Verified and agreed
Ivan Mehar Jan
& Elbar

List of modifications

→ RE-4/2/28

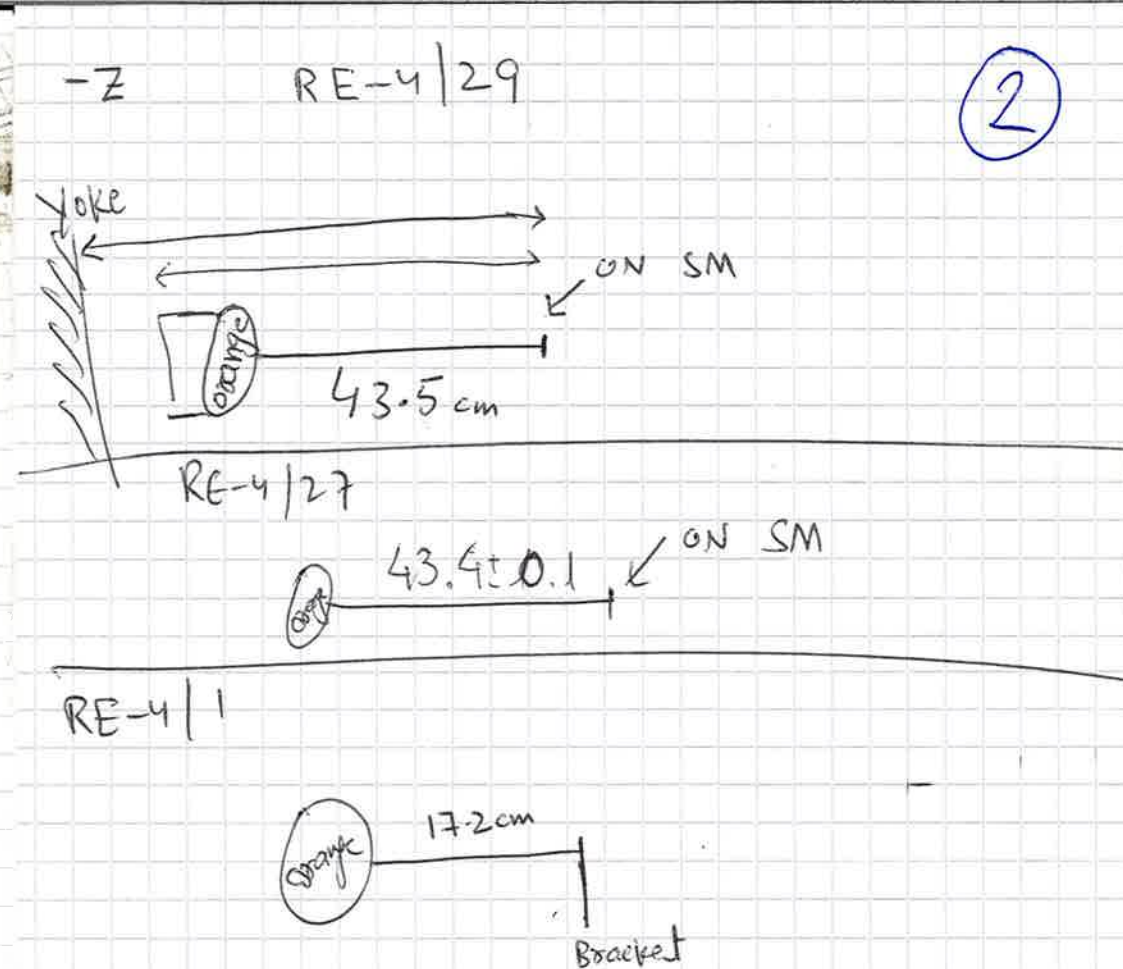
350

345

348 mm

343 A = 7.
350.

ME-4/2/30

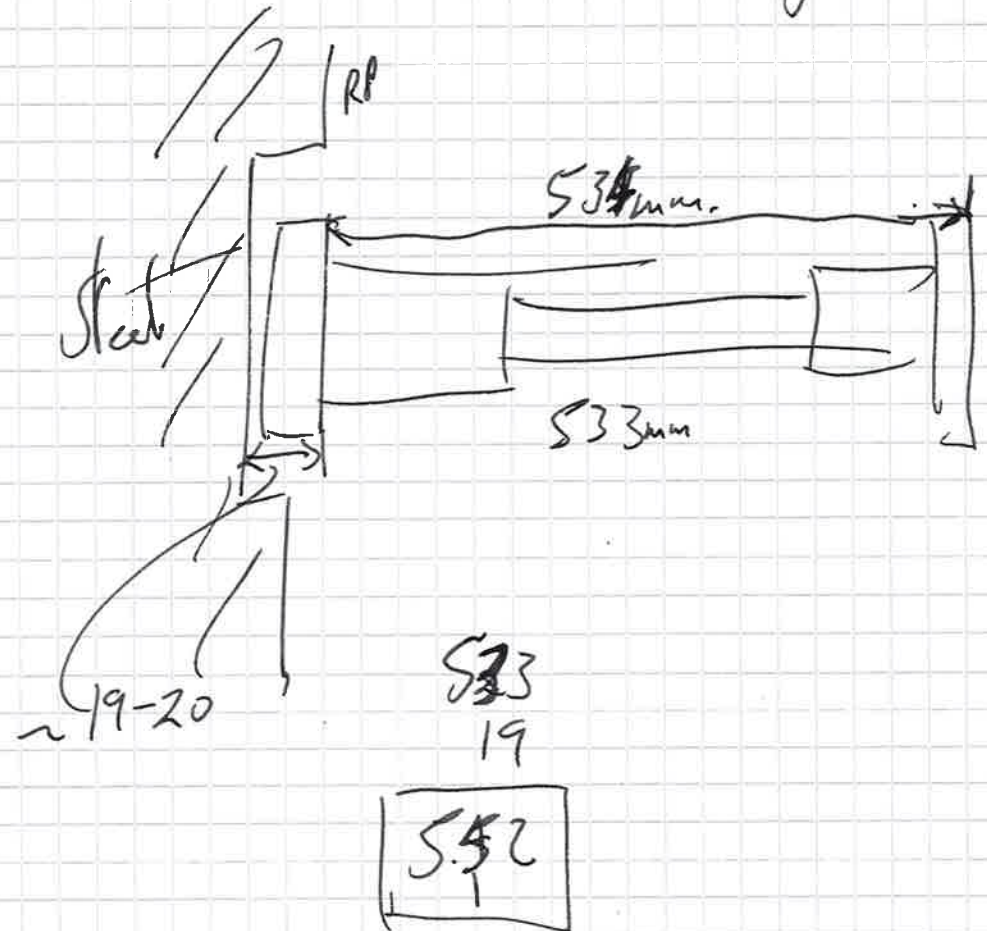
Outer R.

Pocket = machined
steel.

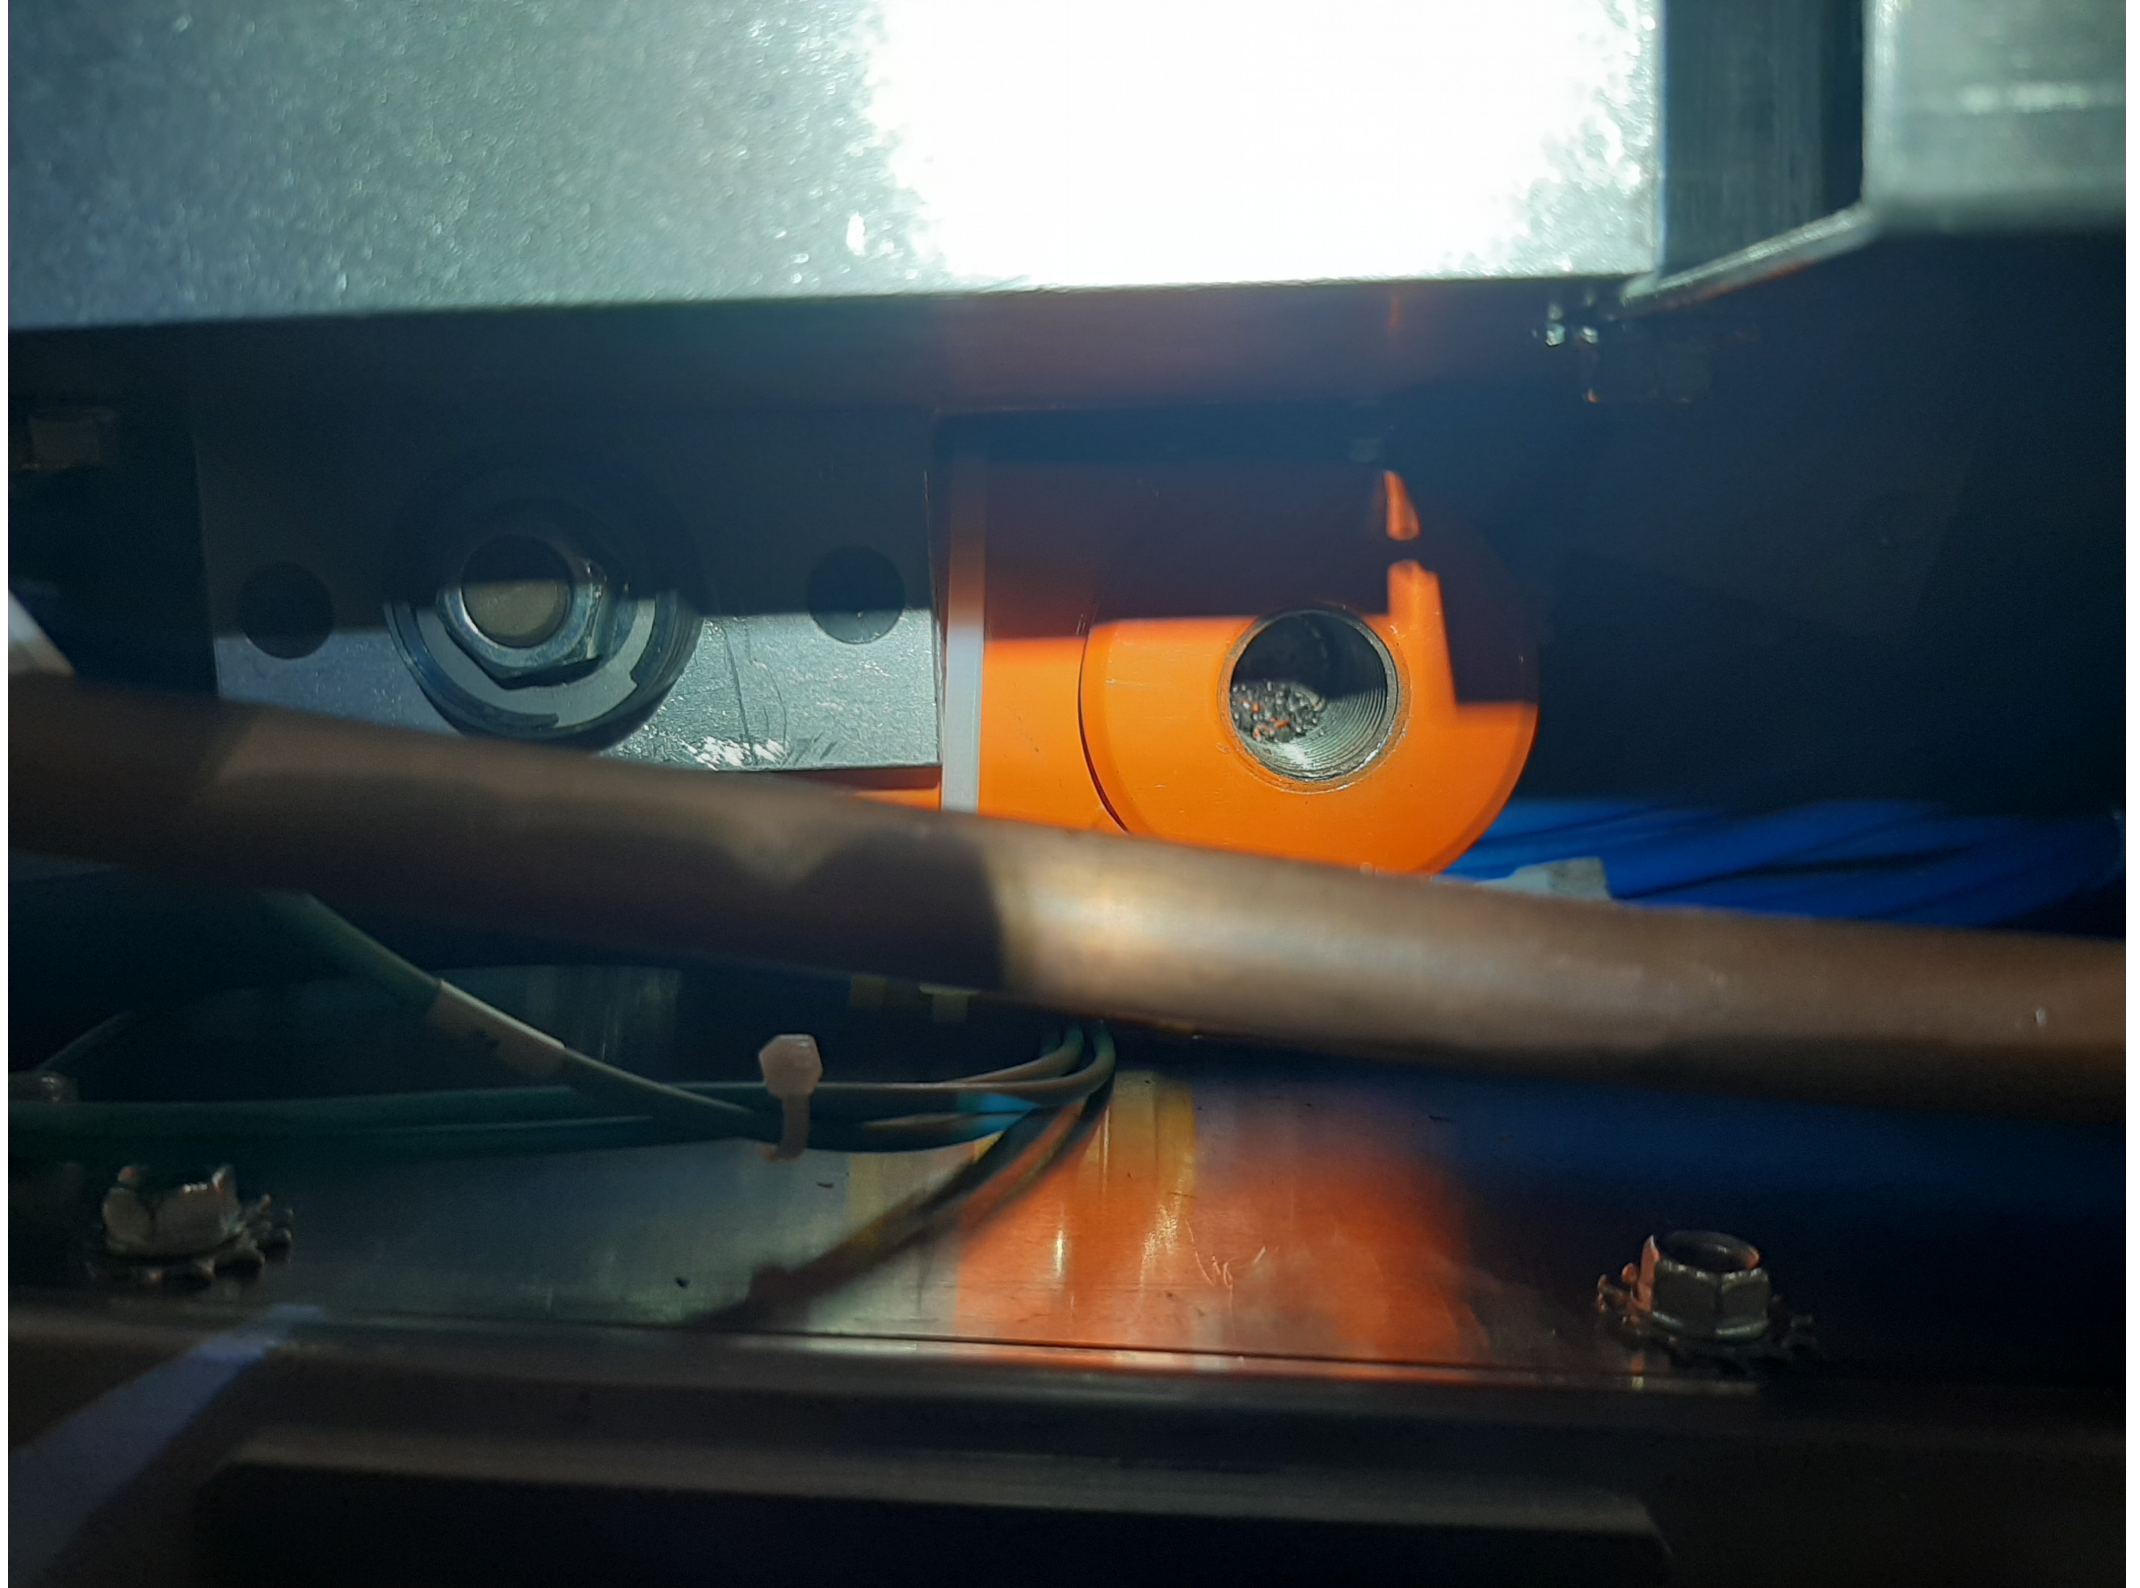
- Can find \geq for R12 #1
- .. \geq for R14 501
- Can find the wear plate 0110
- .. 0124 - 20mm high R
- .. 0124 - 20mm low R
- .. Diagonal for. Need
- Need .. method.
- Can find the removal for thinner. wash 0124
- .. method to adjust.
- P70 possible of LPMP in rotation around 0124

(7)

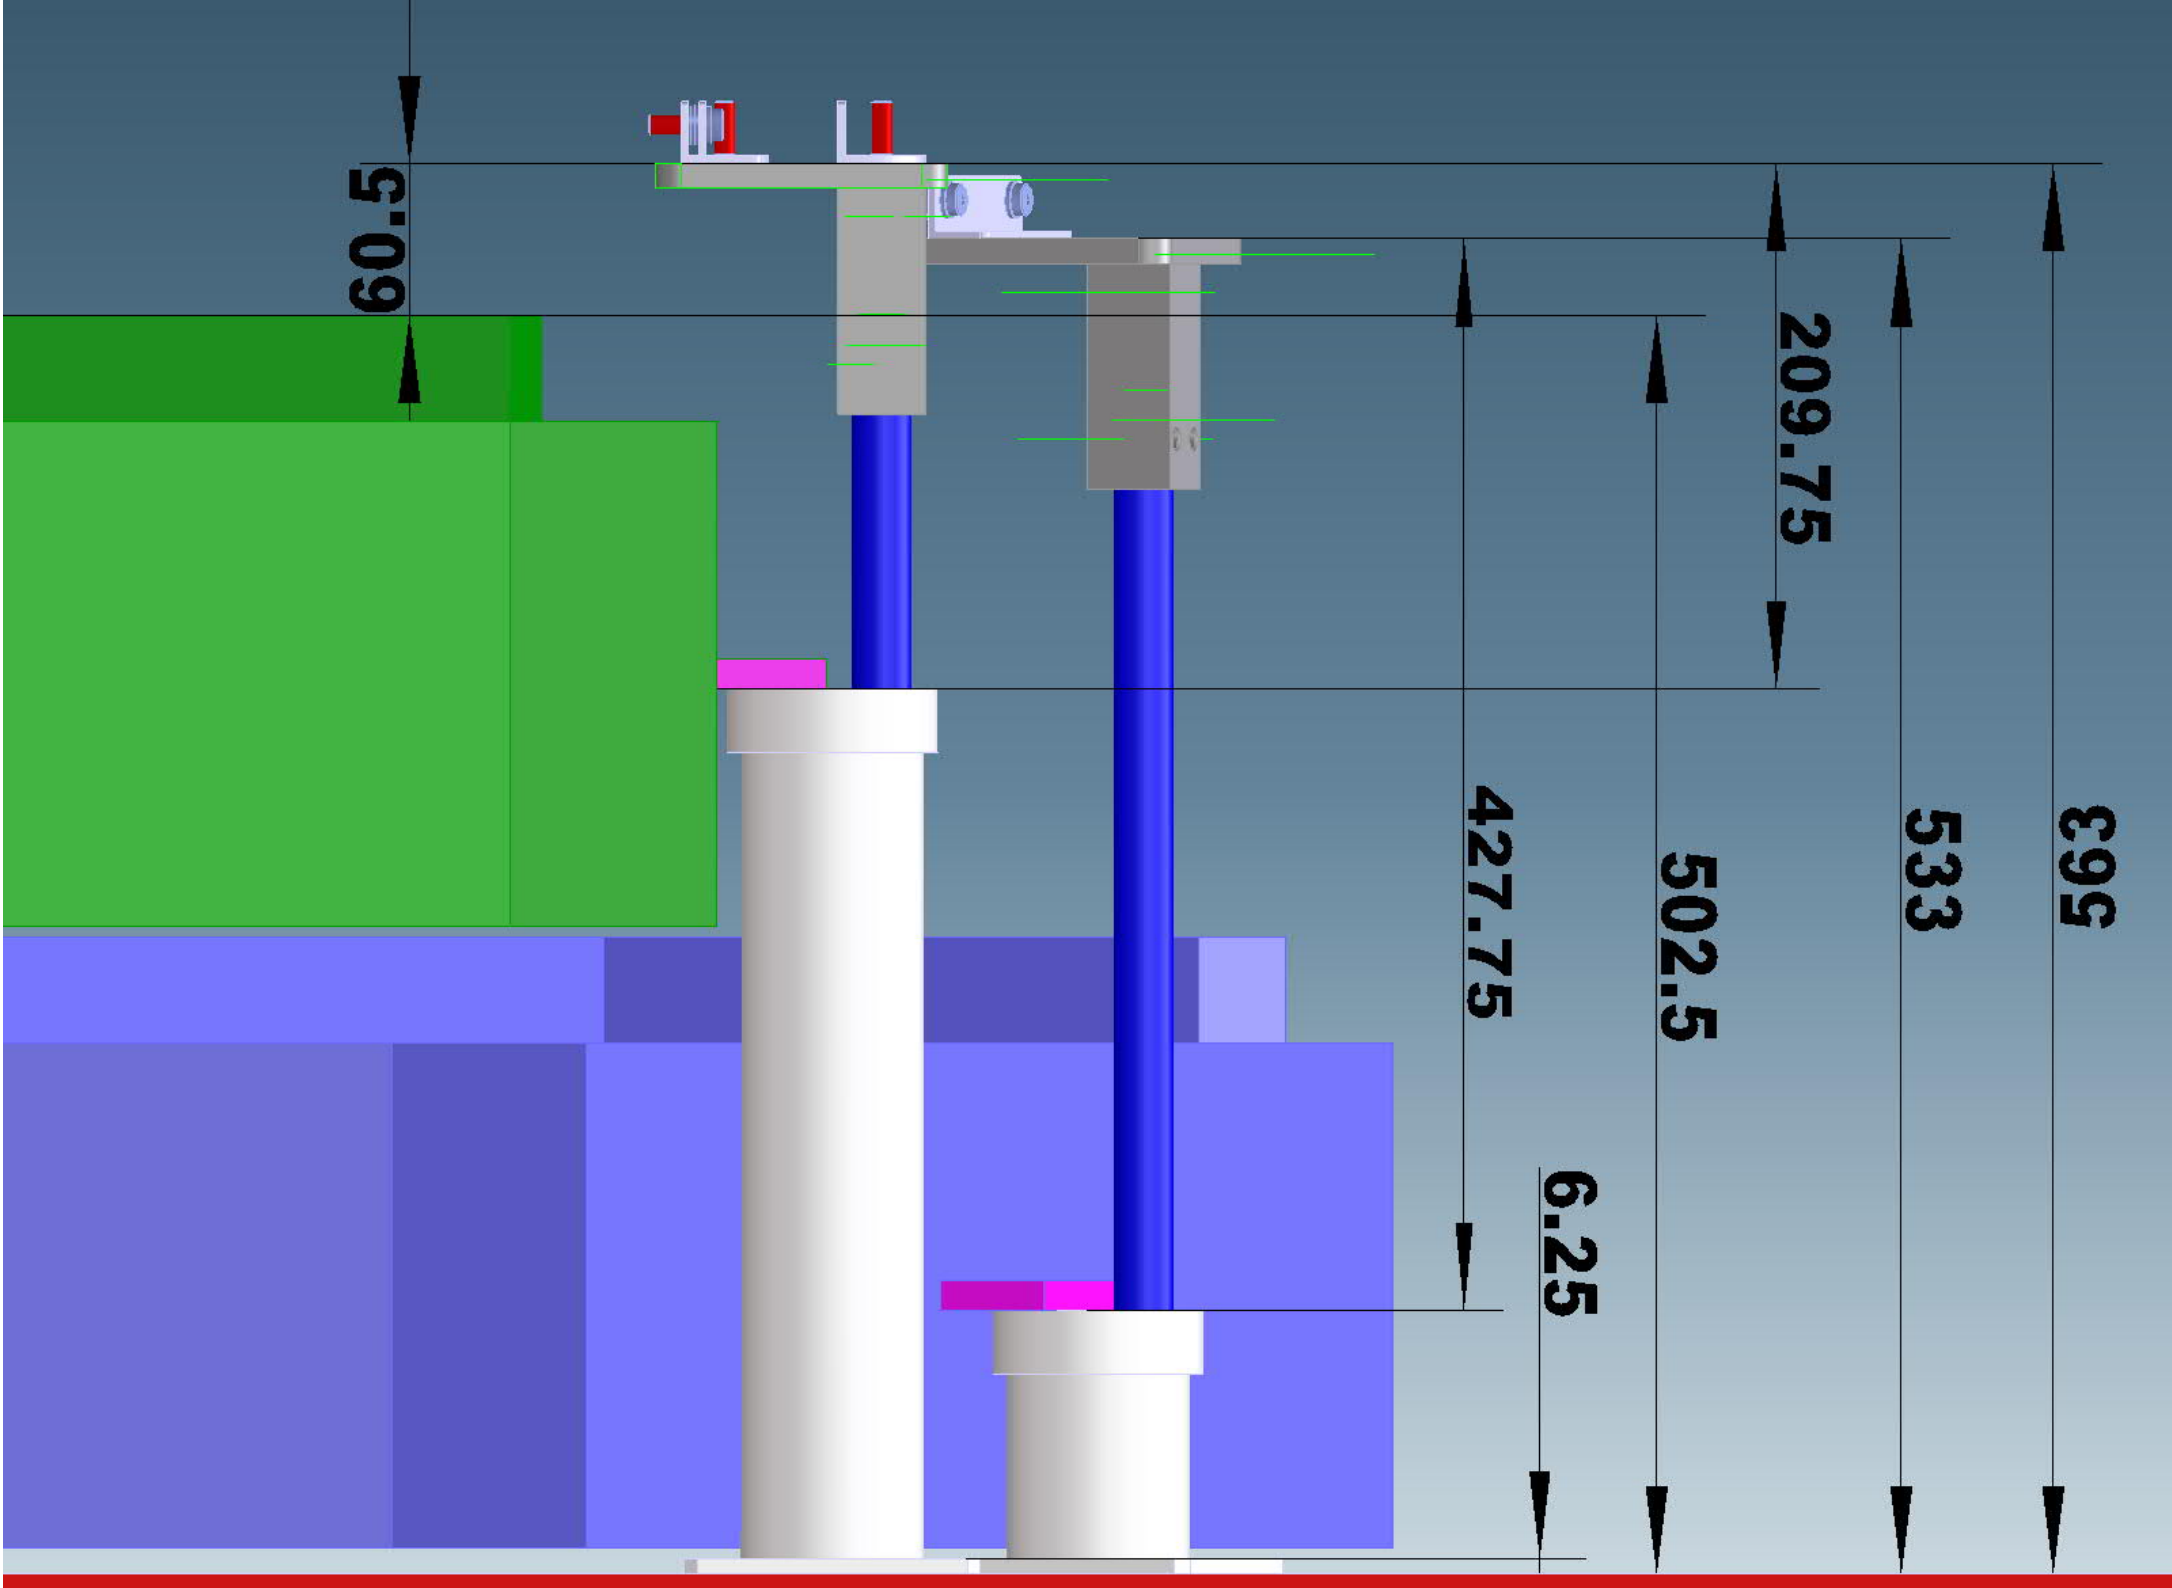
- Confin need to enlarge
M8 screws in ~~top~~
Mounting block at 'top' of
H24

- [M8 Confin need for.

$$27 \times 2 = 62 \text{ H24 Nuts.} \\ \text{or } 100.$$
